CONSTRUCTION MANAGER'S PROJECT MANUAL
Dow Gardens New Welcome Center

BID PACKAGE #3
ADDENDUM #3

February 3, 2025

Project Manual Revisions
Issued as Addendum NO.3
For
The New Dow Welcome Center
Bid Pack #3

6 FASCIA @ MASONRY OVER MULTIPURPOSE ENTRY
SCALE: 1 1/2" = 1'-0"
REFERENCE: 2/ A5.11

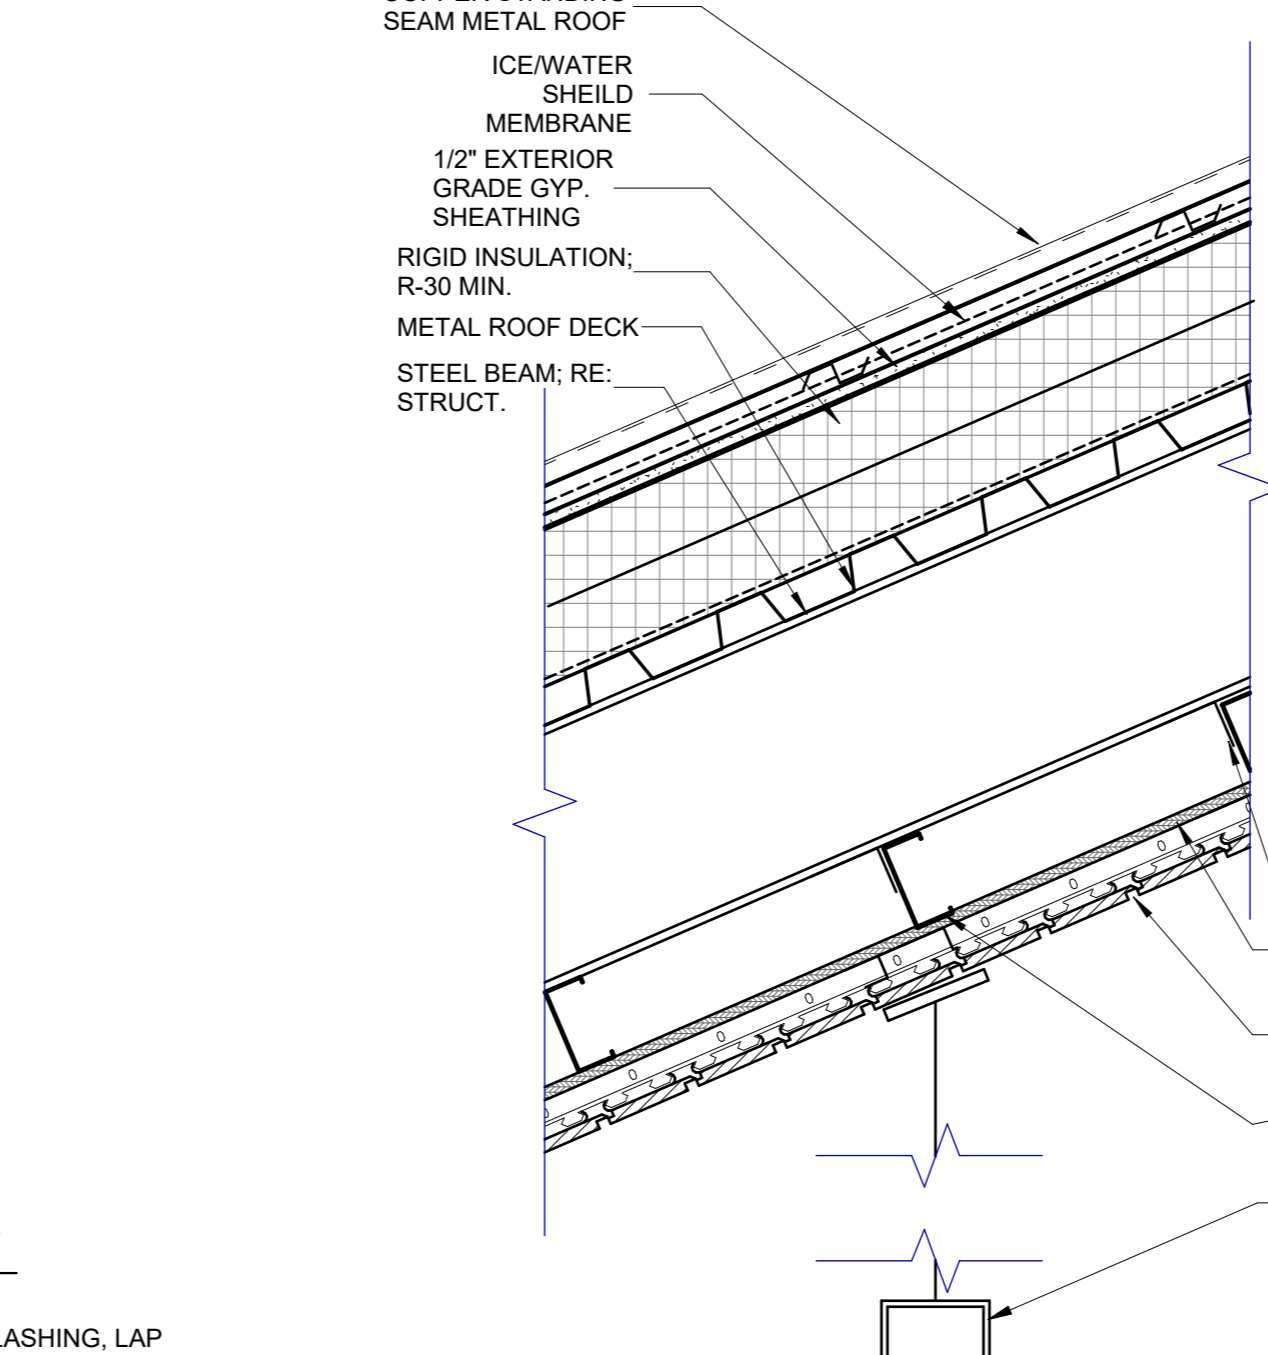
Item A3: Sheet A7.10 (re-issued)

- a. Revised Detail.
 - i. 6/A7.10

1
A7.12
TYP T.O.W. @ S.A.G. CEILING
SCALE: 1 1/2" = 1'-0"

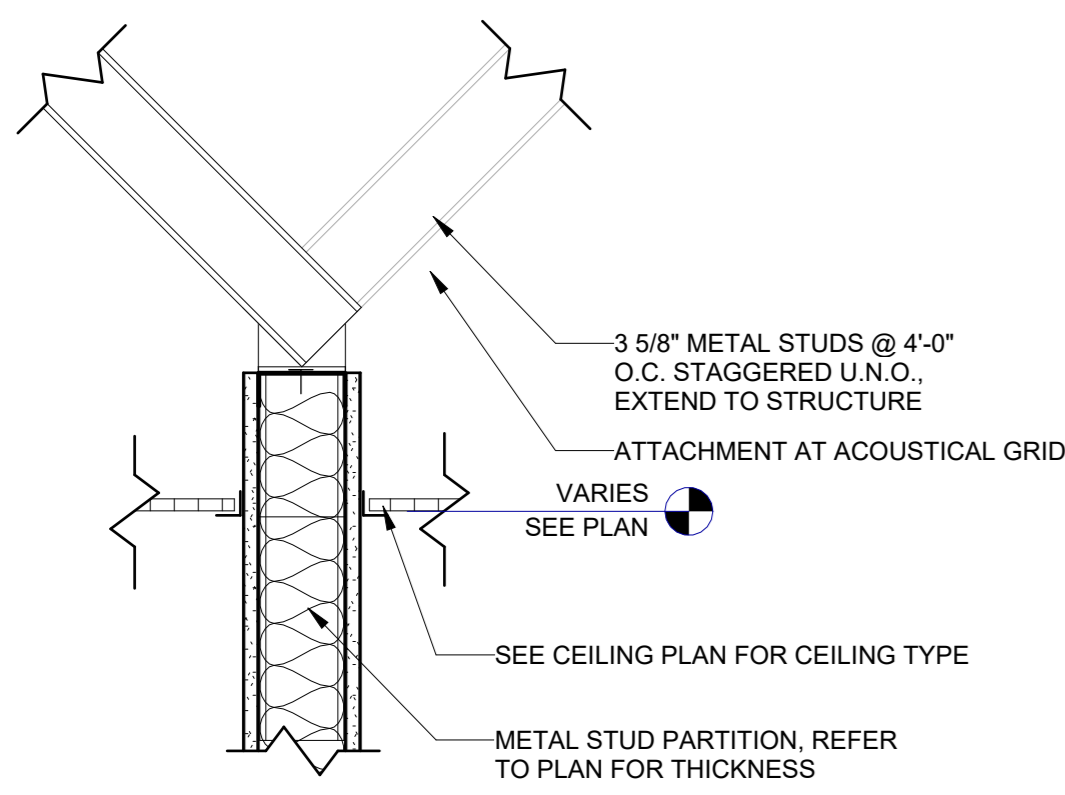
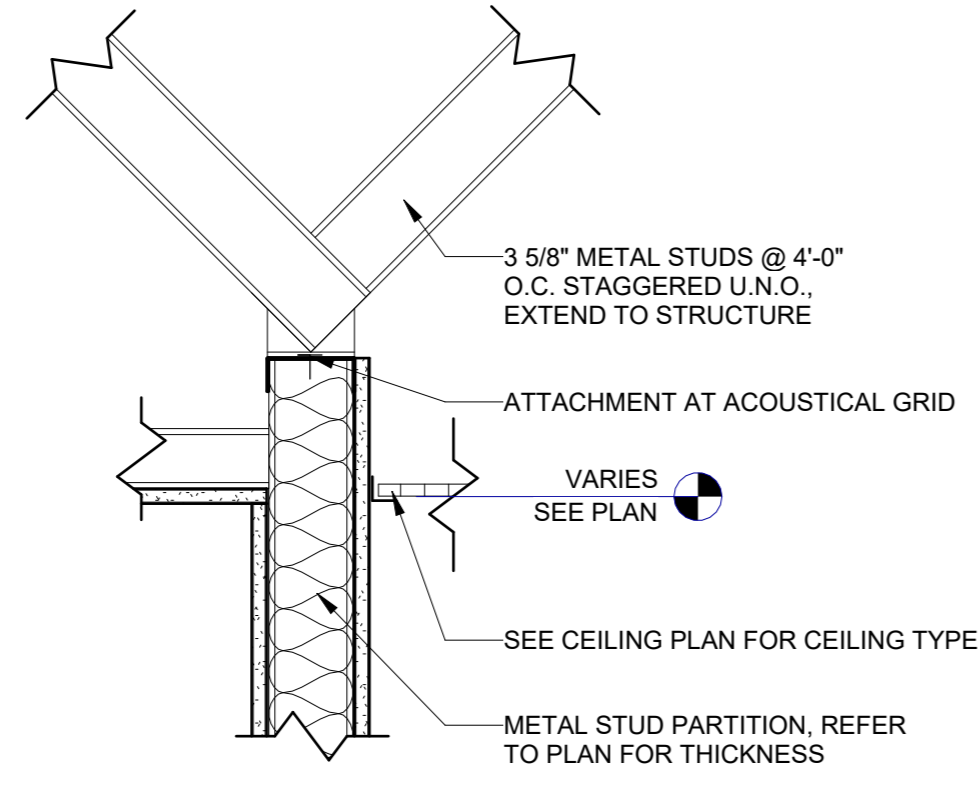
- a. Revised Details
 - i. 1/A7.11
 - ii. 2/A7.11

8
A7.12
CANOPY EDGE DETAIL
SCALE: 1 1/2" = 1'-0"
REFERENCE: 3/A5.10

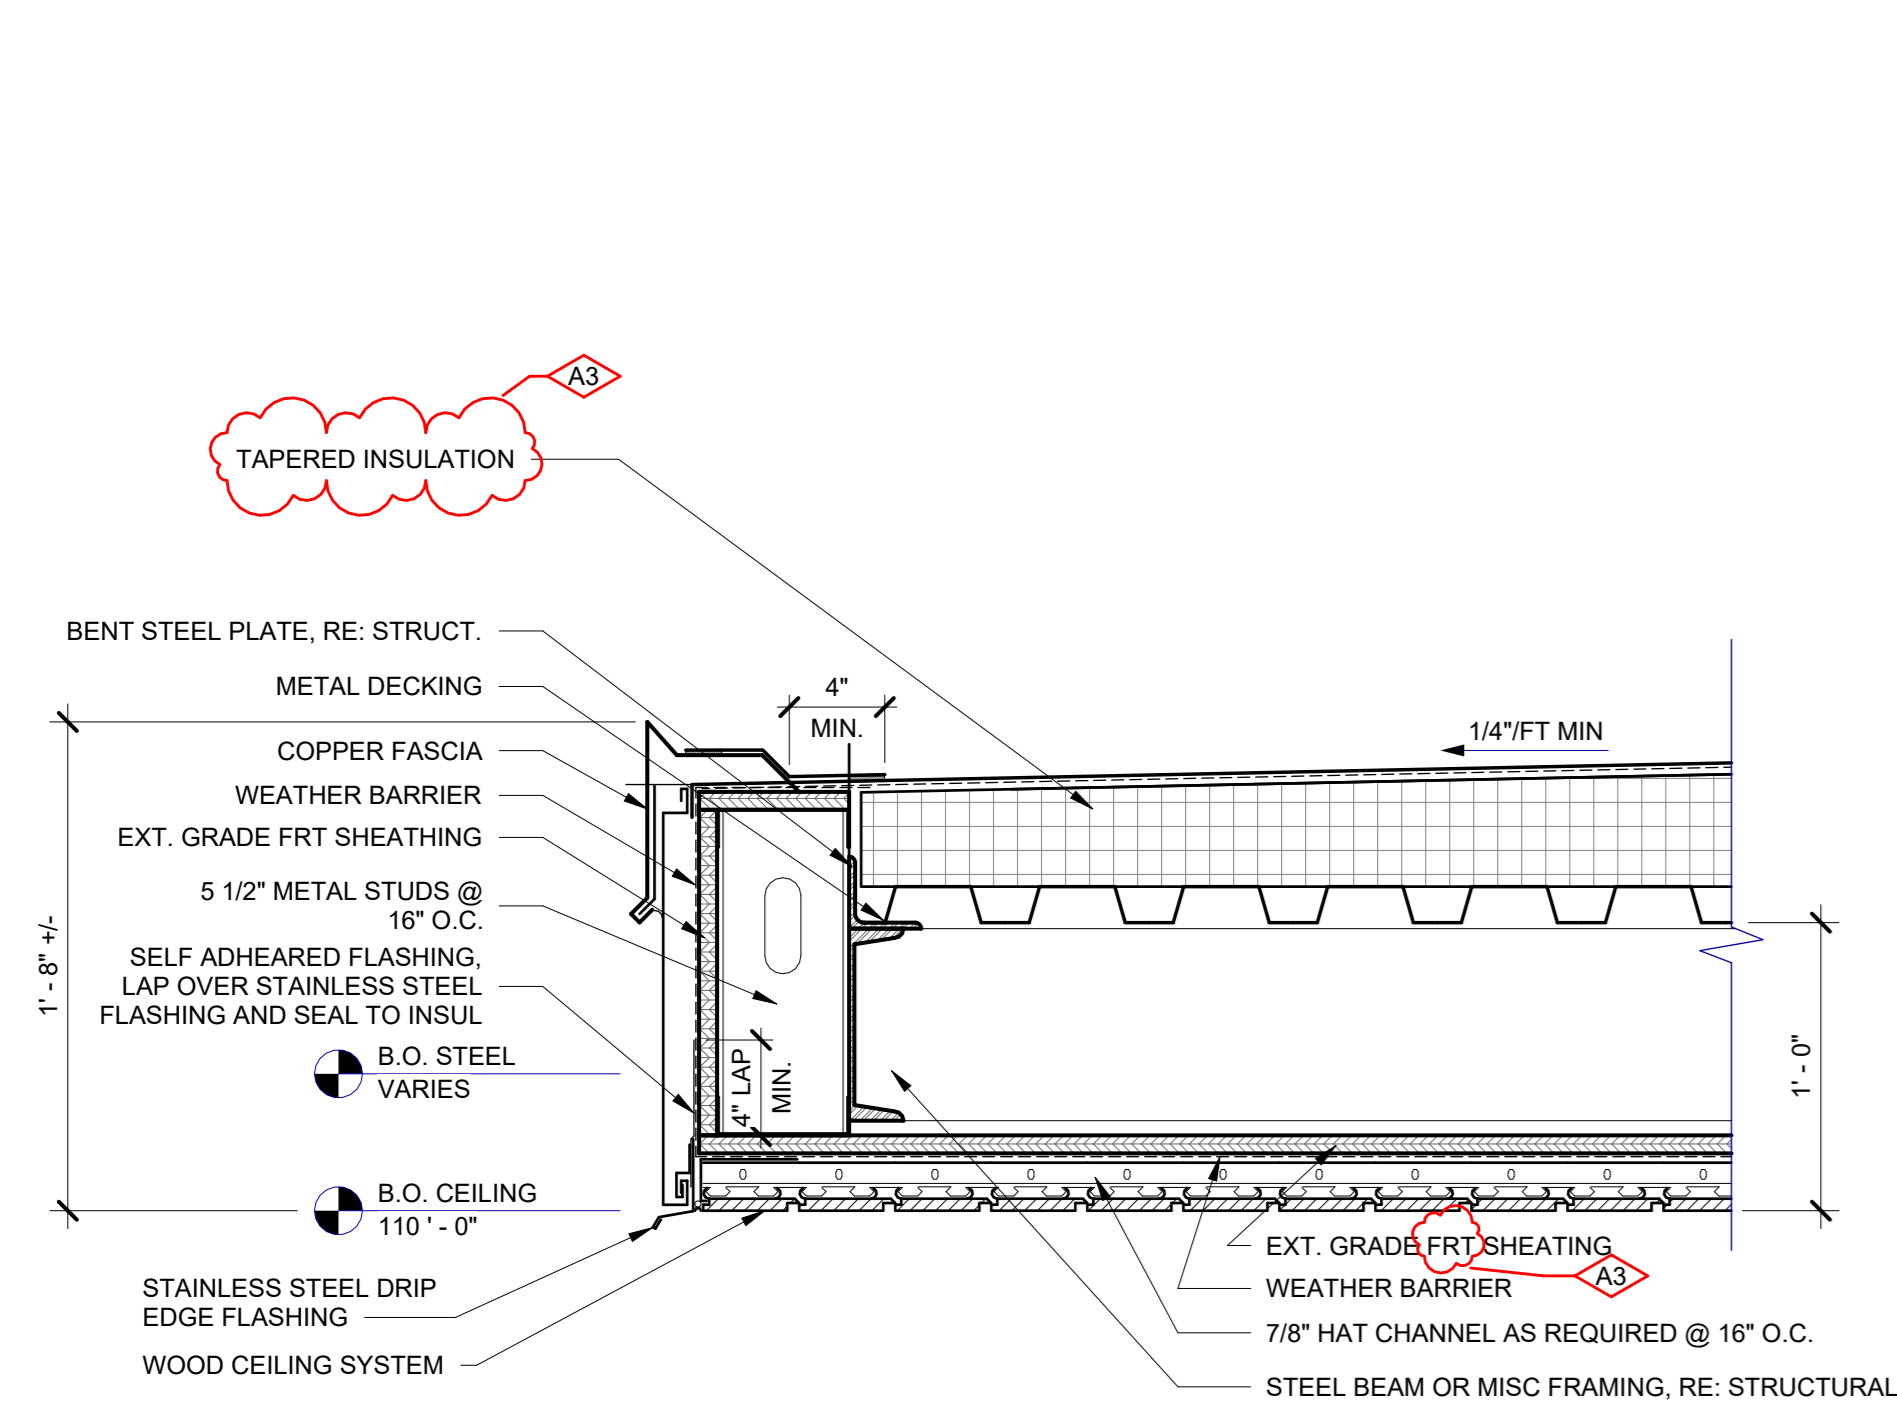
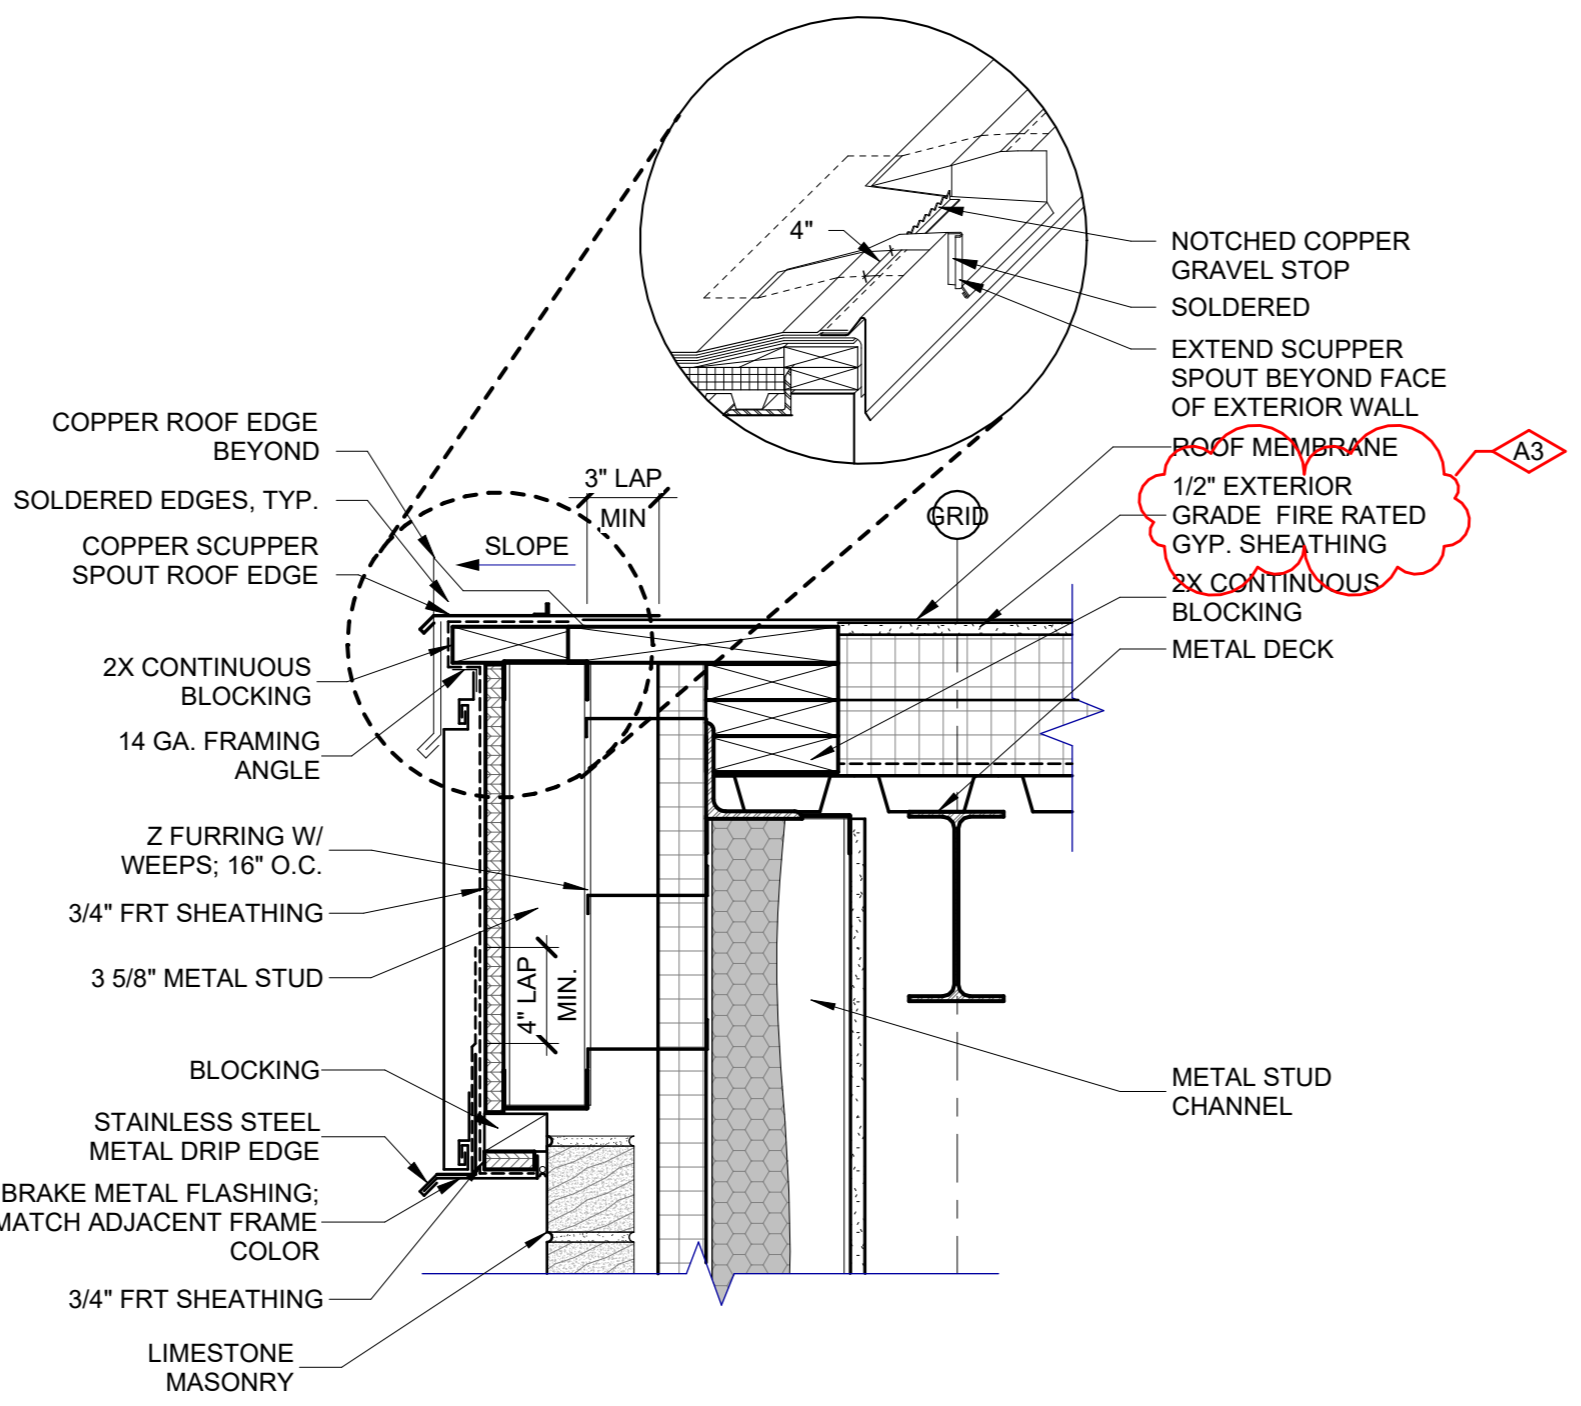
- a. Revised Detail.
 - i. 8/A7.12
 - ii. 9/A7.12
- b. New Detail
 - i. 11/A7.12
 - ii. 12/A7.12
